SUBJECT: Application G-15566

Well #1 (CLAC 2331)

GROUNDWATER/SURFACE WATER CONSIDERATIONS

RE: GW File Number G-15566

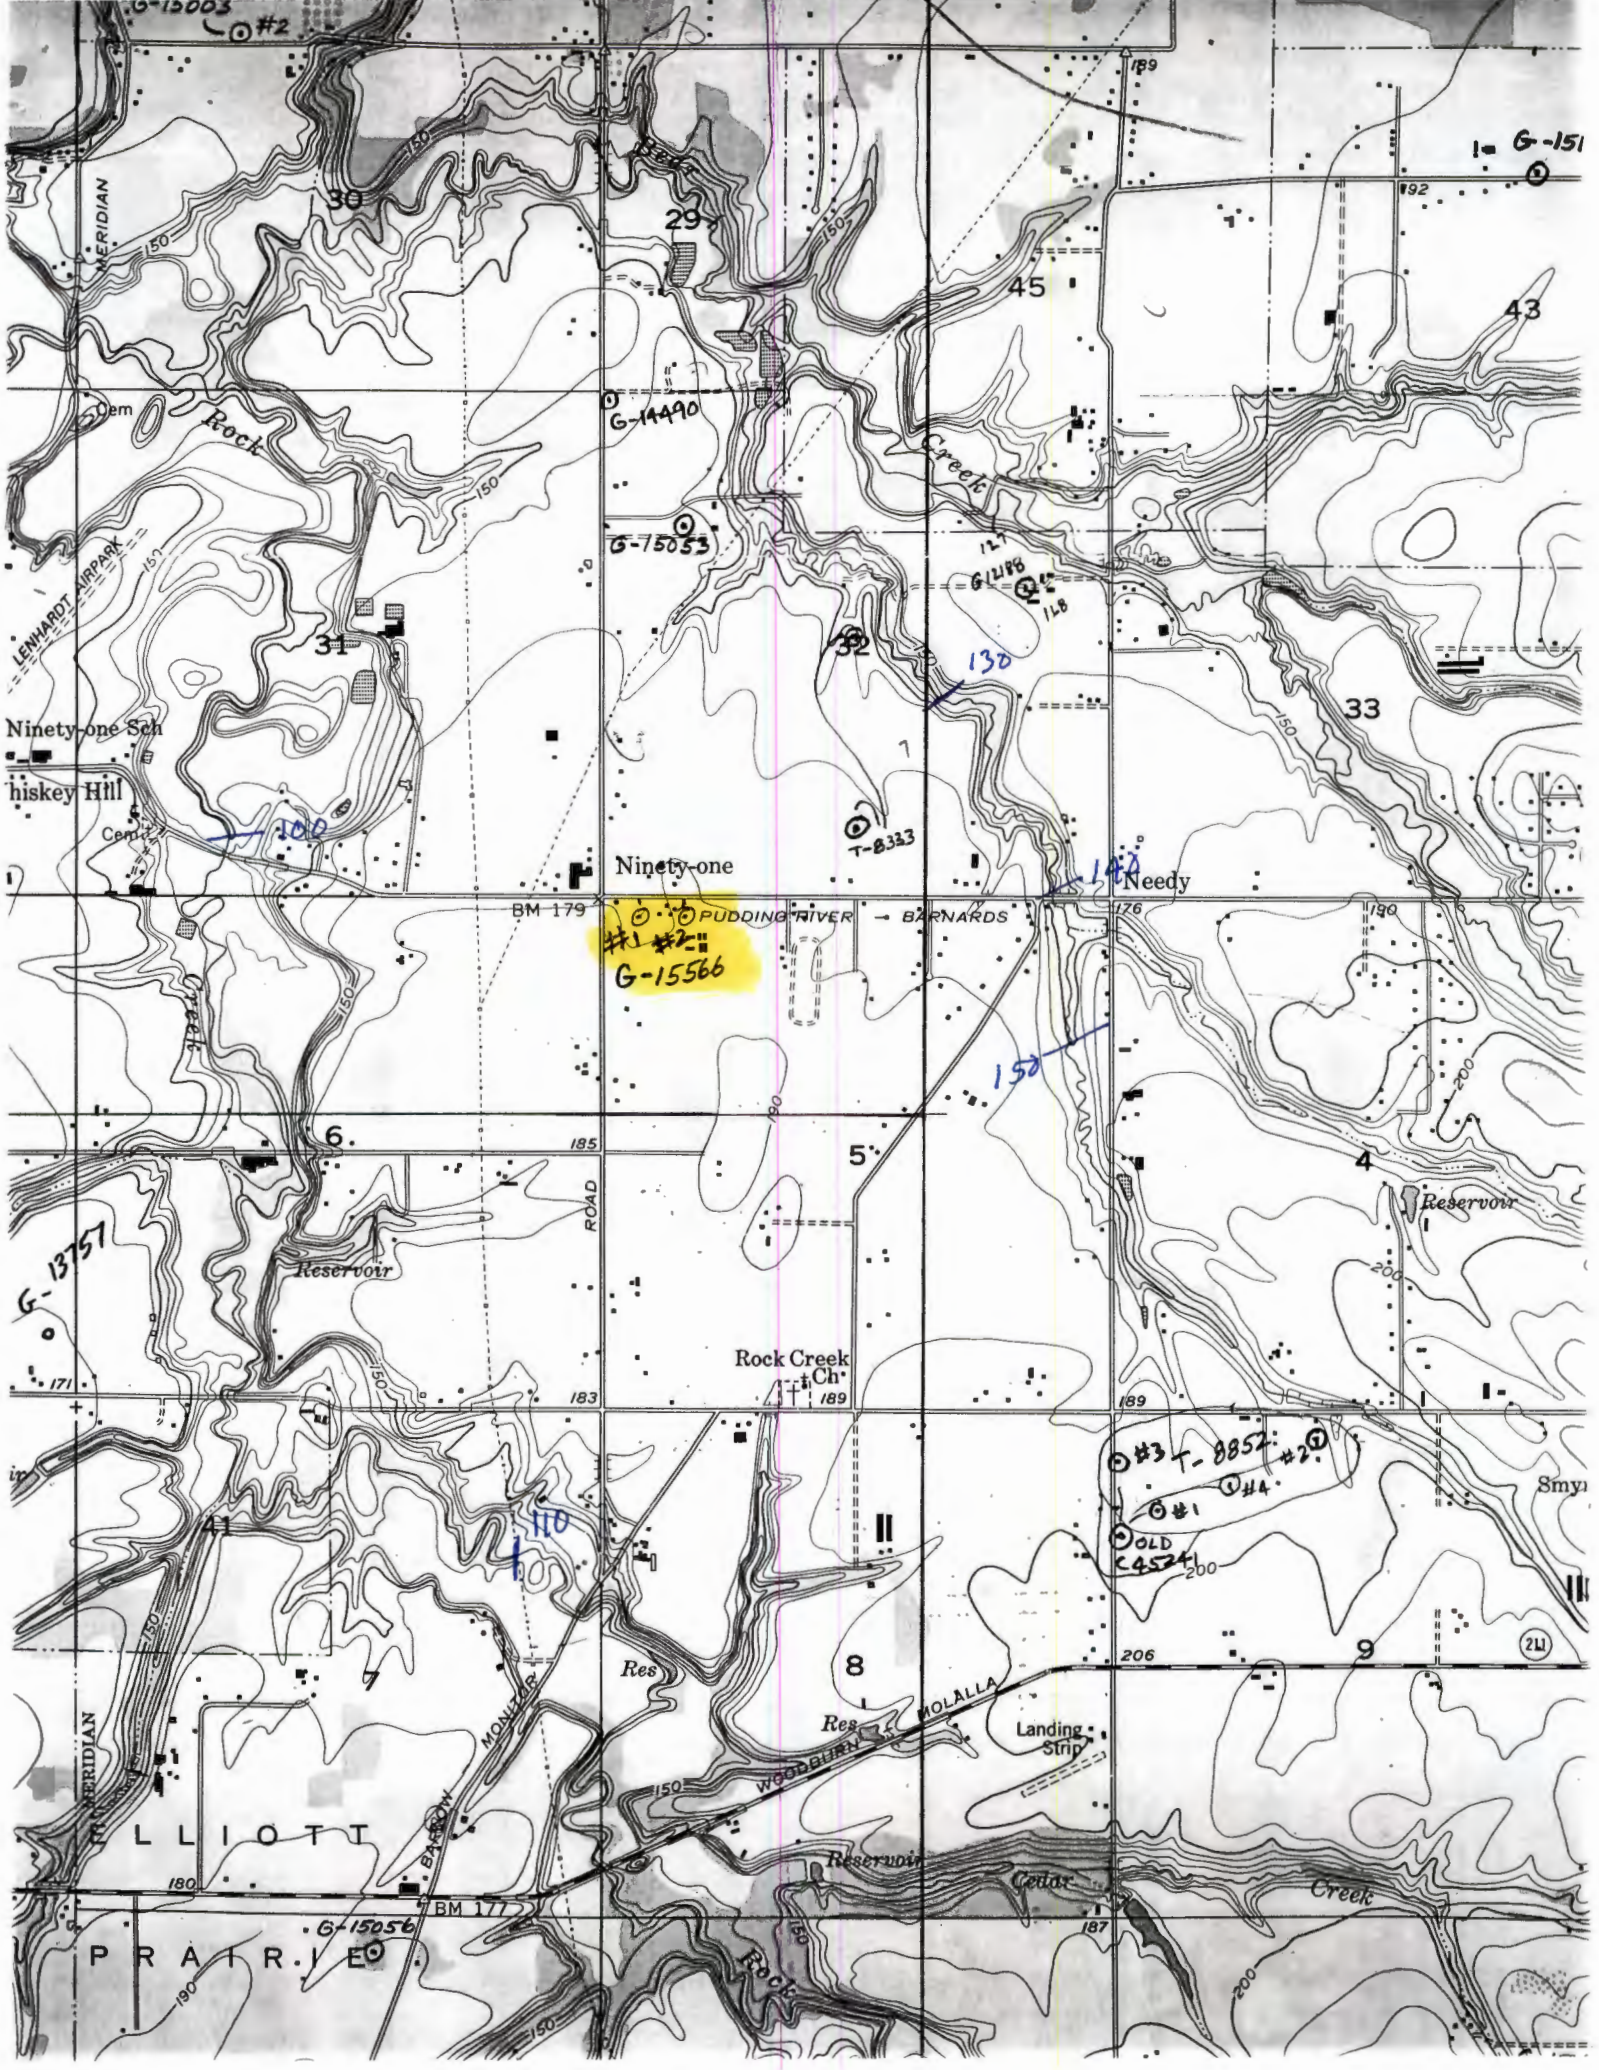
Comments: The WSP's plate 1 projects the May '63 water table at
 170 to 175' at the site of the two wells
